TECHNICAL BULLETIN

March 21, 2023

Conveyor Design Change with Welding Specs

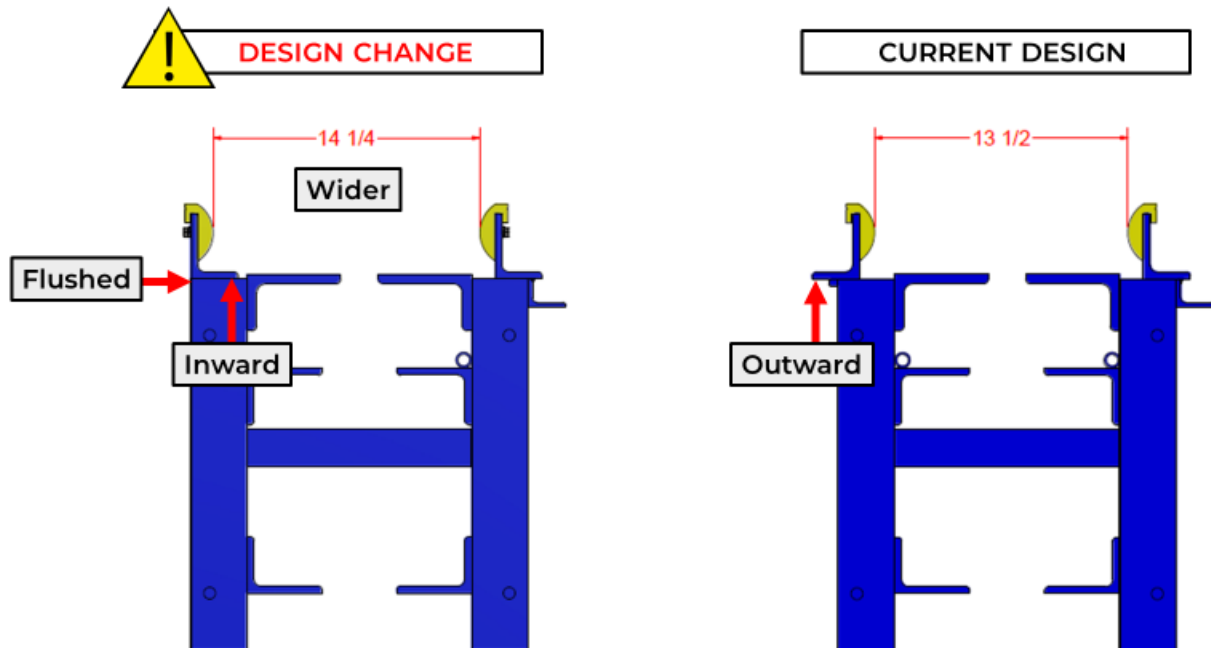
Same Function
Same 5" Centerline
Move Conveyor Up or Down
Follow Updated Welding Specs

The Conveyor Design Change standardizes the FWP and RWP installation by using the same 5" centerline for conveyor and equipment installs, while providing the flexibility to move the Conveyor up or down without altering the centerline.

IMPORTANT: Nothing Changes When Placing NEW Orders.
Follow Installation Dimensions and Updated Welding Specs Below.
